**SOLICITATION AMENDMENT
MODIFICATION DE L'INVITATION**

Title - Sujet Security Guard Services	
Solicitation No. - N° de l'invitation 47419-216063/B	Amendment No. - N° modif. 001
Client Reference No. - N° de référence du client 47419-216063	Date 2021-06-17
GETS Reference No. - N° de référence de SEAG PW-\$TOR-016-8053	
File No. - N° de dossier TOR-0-43034 (016)	CCC No./N° CCC - FMS No./N° VME
Solicitation Closes - L'invitation prend fin at - à 02:00 PM Eastern Daylight Saving Time EDT on - le 2021-07-07 Heure Avancée de l'Est HAE	
F.O.B. - F.A.B.	
Plant-Usine: <input type="checkbox"/> Destination: <input type="checkbox"/> Other-Autre: <input type="checkbox"/>	
Address Enquiries to: - Adresser toutes questions à: Grozdanovski, Tase	Buyer Id - Id de l'acheteur tor016
Telephone No. - N° de téléphone (647) 926-3756 ()	FAX No. - N° de FAX () -
Destination - of Goods, Services, and Construction: Destination - des biens, services et construction: See Herein

Amendment 001 has been issued to:

1. Extend the solicitation period,
2. Provide answers to the following questions, and
3. Make changes to Annex A – Statement of Work.

Example 1:

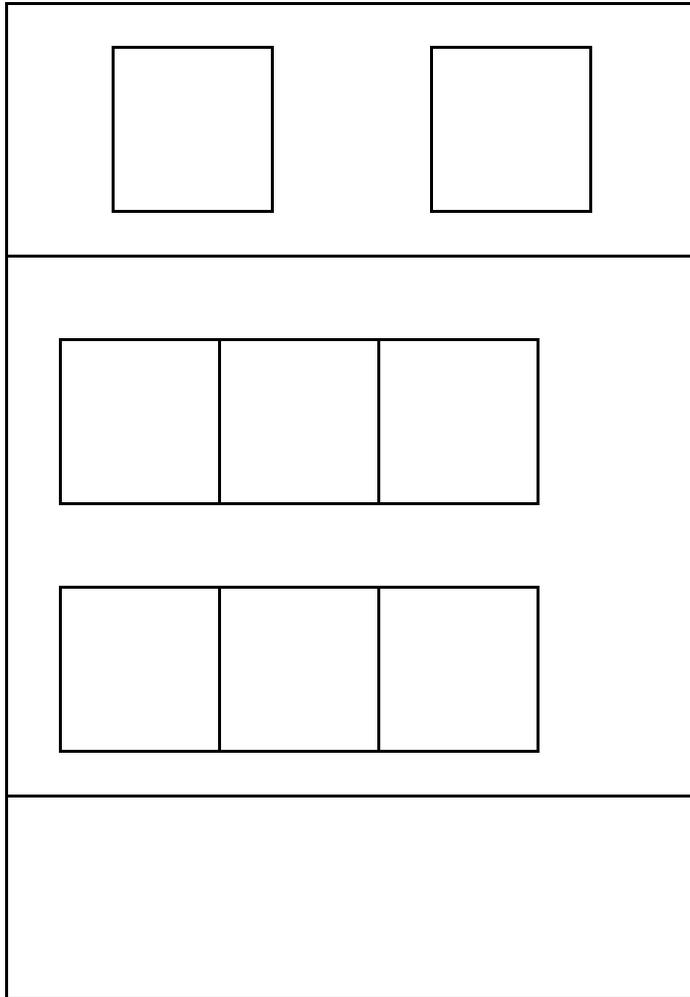
Q13. Regarding Vehicles: Can you provide a diagram of how seating is configured for the 10 and 12 passenger vehicles as well as how the ten dividers etc. would be positioned?

A13. Vehicles are required for 5/7/8/12 passengers for this requirement (Annex A, Appendix 1). Here are examples of seating configurations of transport vehicles:

- Driver's Cabin

- Passenger cabin bench seats of two rows
- Space available to get to the back row on the passenger side
- Plexiglass between the driver and passenger compartments

- Perforated-metal cage between passenger and luggage compartments

Ford Transit MR 150 XL
Ford Transit MR 350 XL

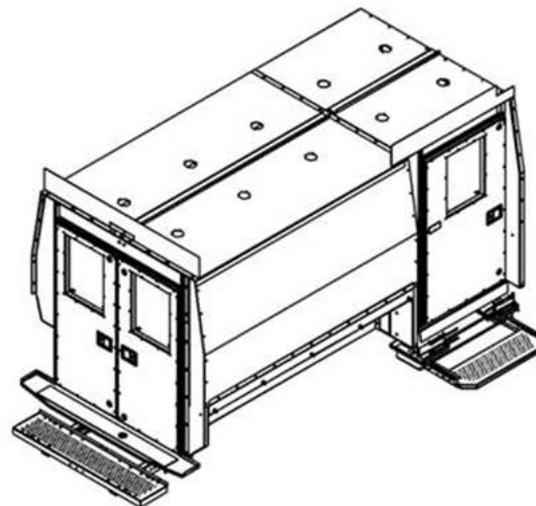
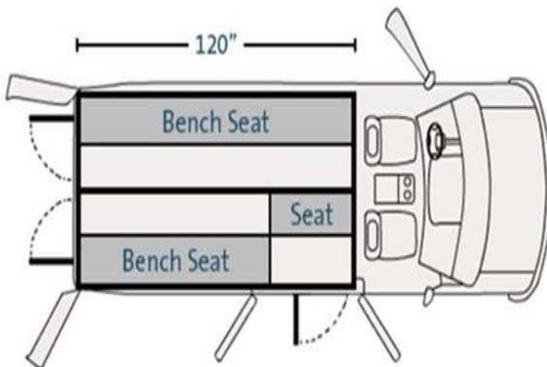
Q14. Regarding Vehicles: Can you provide the make and models (with pictures) of the current vehicles in use that are compliant?

A14. Vehicles that are currently being utilized for operations belong to contracted service providers, therefore the CBSA cannot comment on them.

However, we can provide some of the examples that the CBSA uses:
